TECHNICAL MEMORANDUM

Date: July 3, 2013
To: Mike Tassano, City of Pleasanton
From: Kathrin Tellez and Sarah Nadiranto
Subject: **Transportation Assessment for Commons at Gateway**

WC11-2878.02

Figure 10.

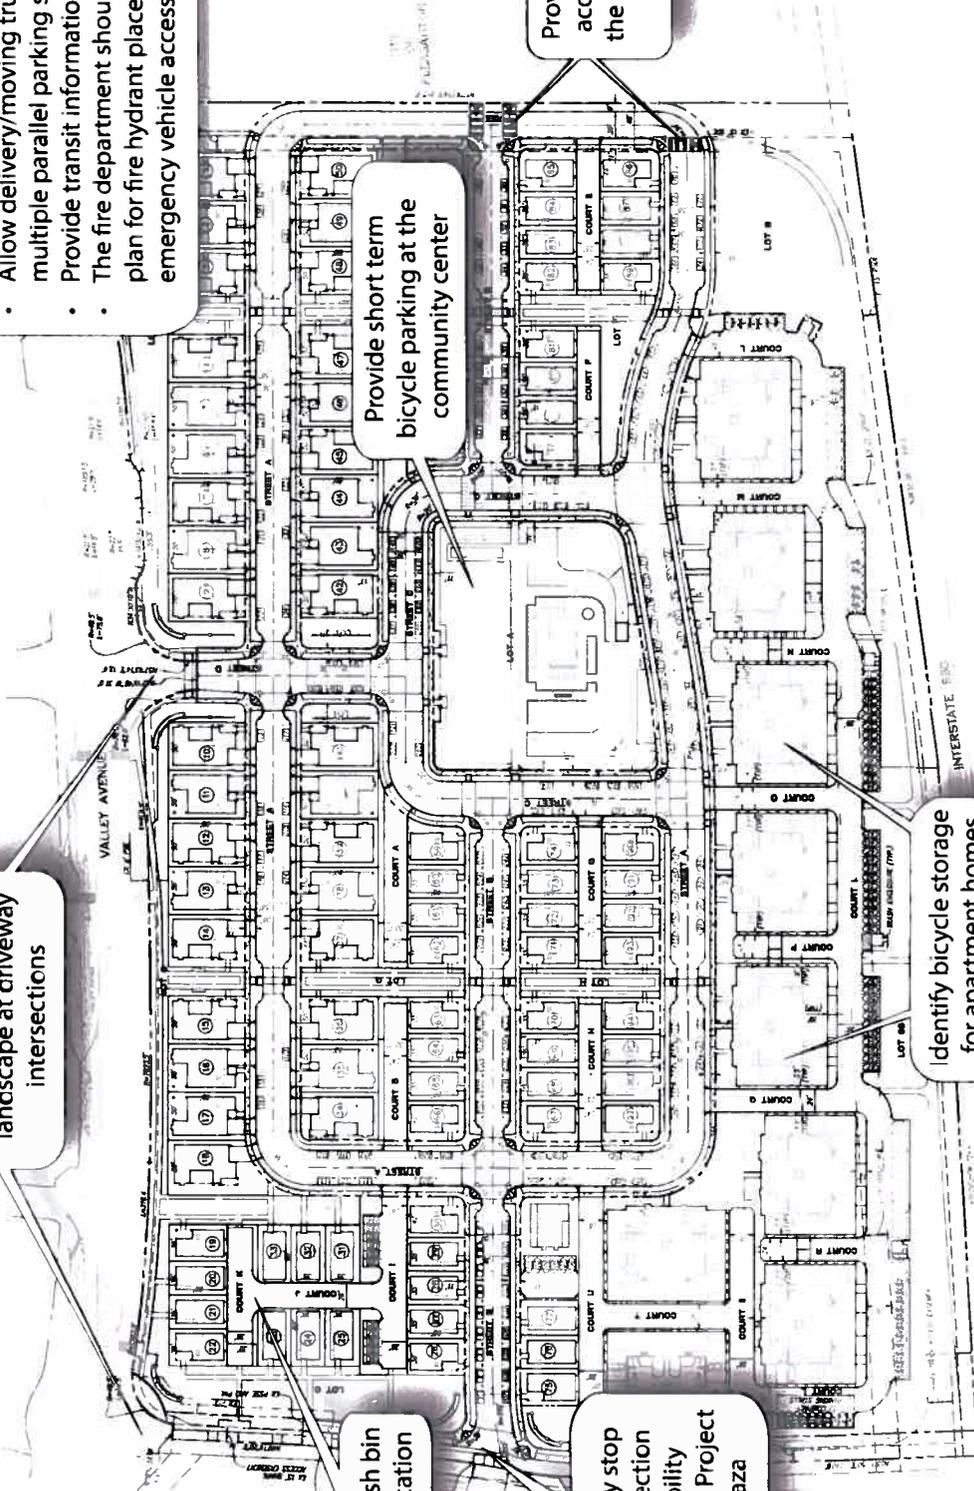
Reduce sight distance conflicts by maintaining landscape at driveway intersections

Identify trash bin pick-up location

Provide an all-way stop controlled intersection and a high-visibility crosswalk from the Project to Gateway Plaza

Provide short term bicycle parking at the community center

Provide crosswalks and access gates between the project, open space and trail.

Identify bicycle storage for apartment homes

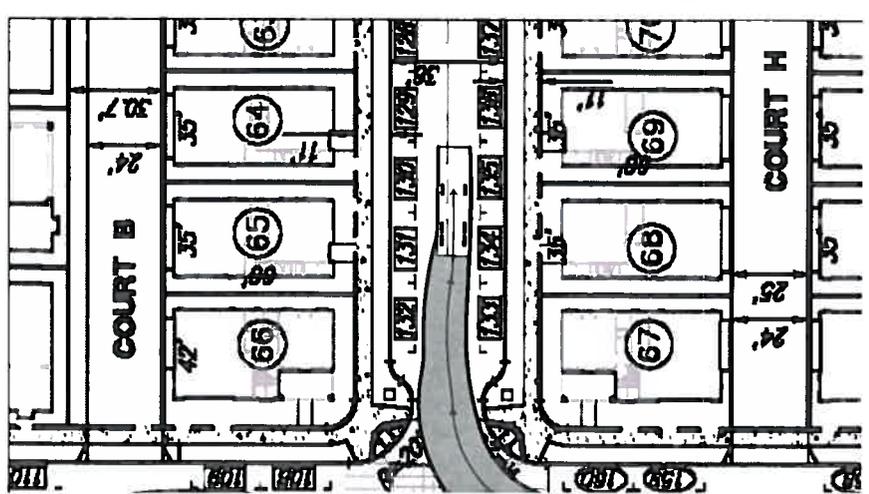
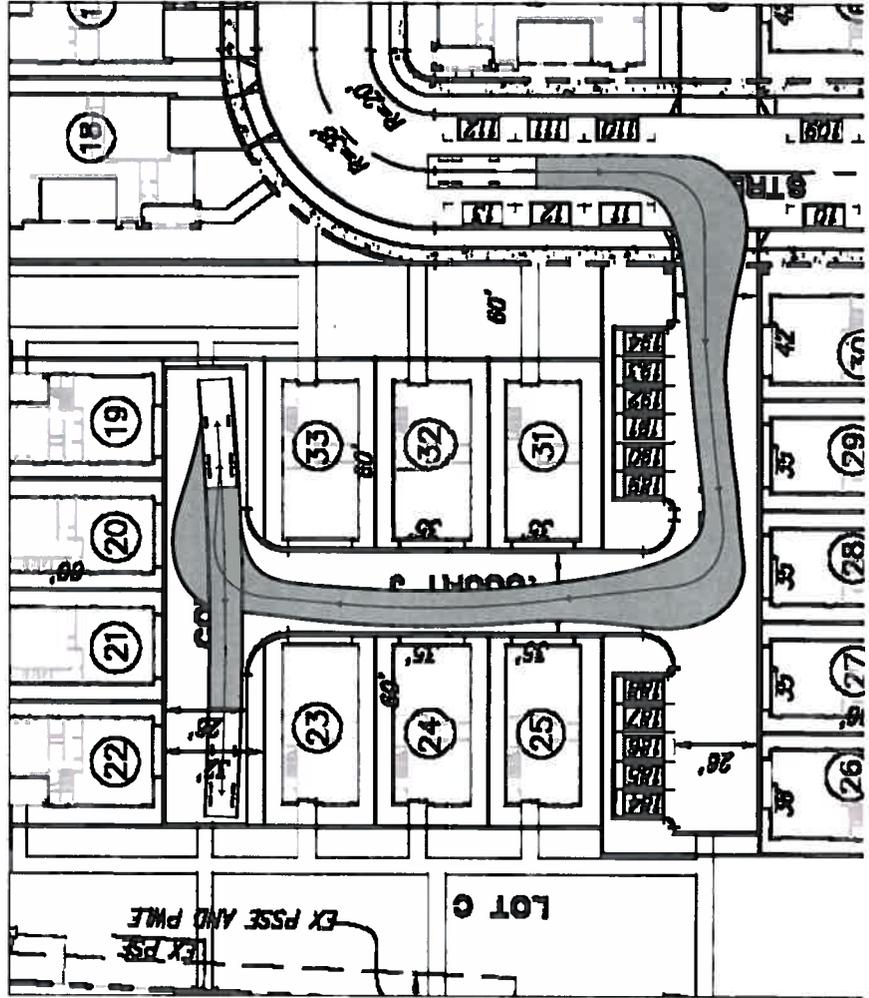
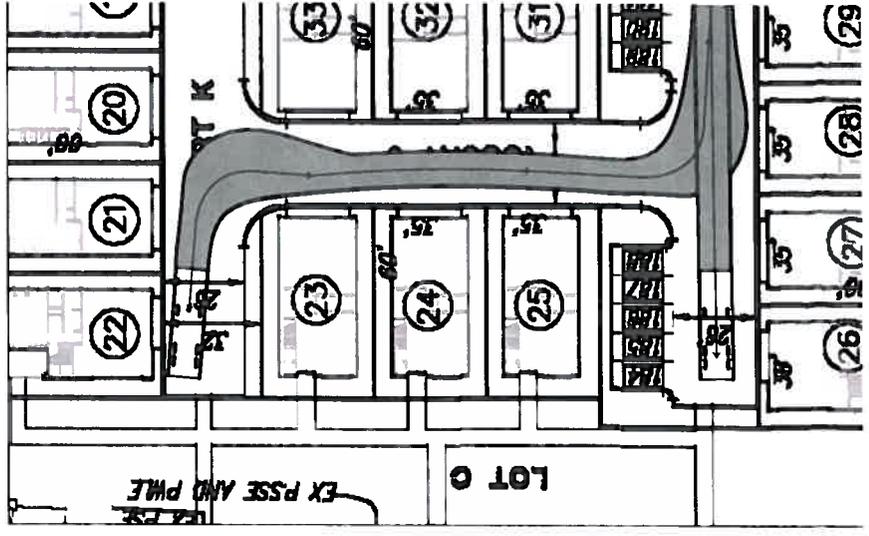
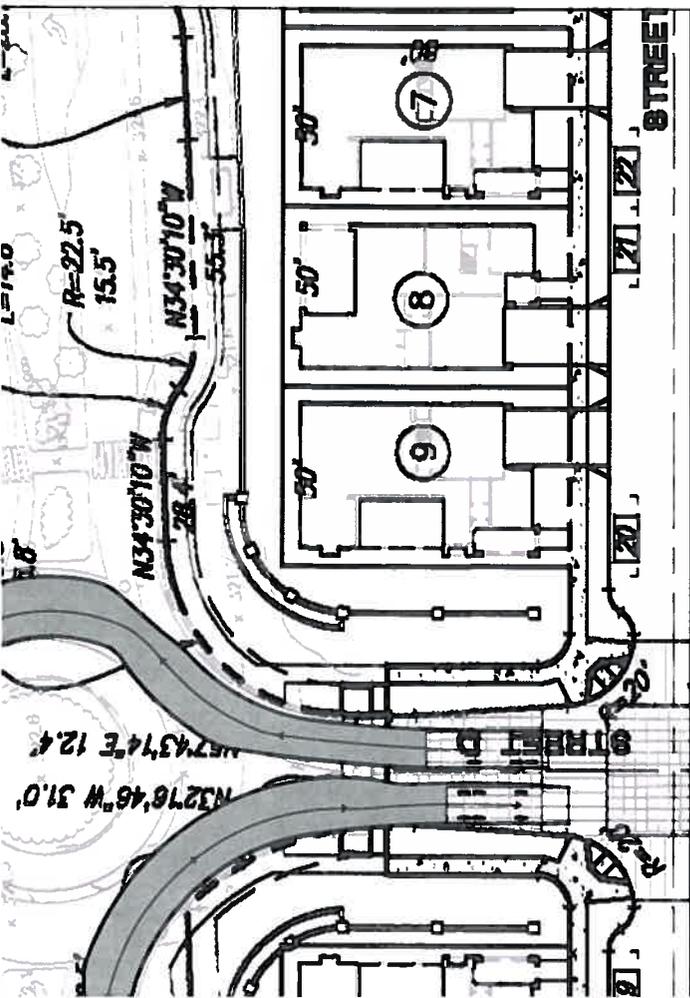
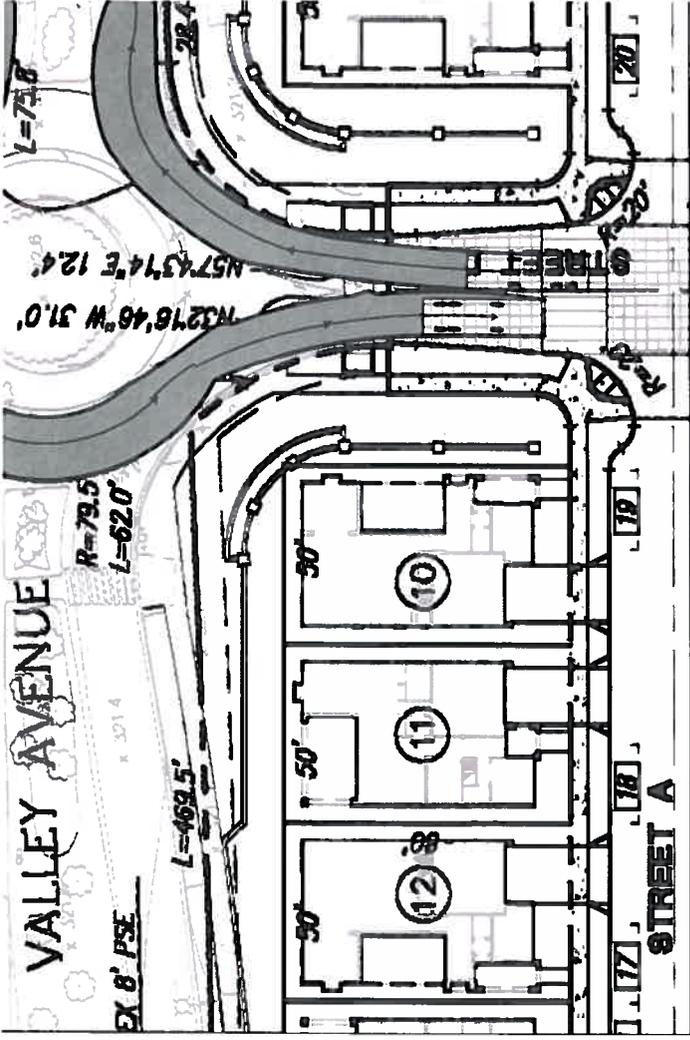
A fire station is located on Bernal Avenue approximately 1/4-mile from the Project site. Emergency vehicles have multiple ways of accessing the site from Bernal Avenue and Valley Avenue so if one entrance is blocked, alternative access would be available. An AutoTurn assessment indicates that a large fire truck would enter into the opposite travel lane when navigating through the site. Large emergency vehicles may have difficulty accessing homes on Courts J and K.

Recommendation: The fire department should review the site plan for fire hydrant placement and emergency vehicle access. Results of the AutoTurn assessment are shown on **Figure 11** for their use in reviewing site access and circulation.
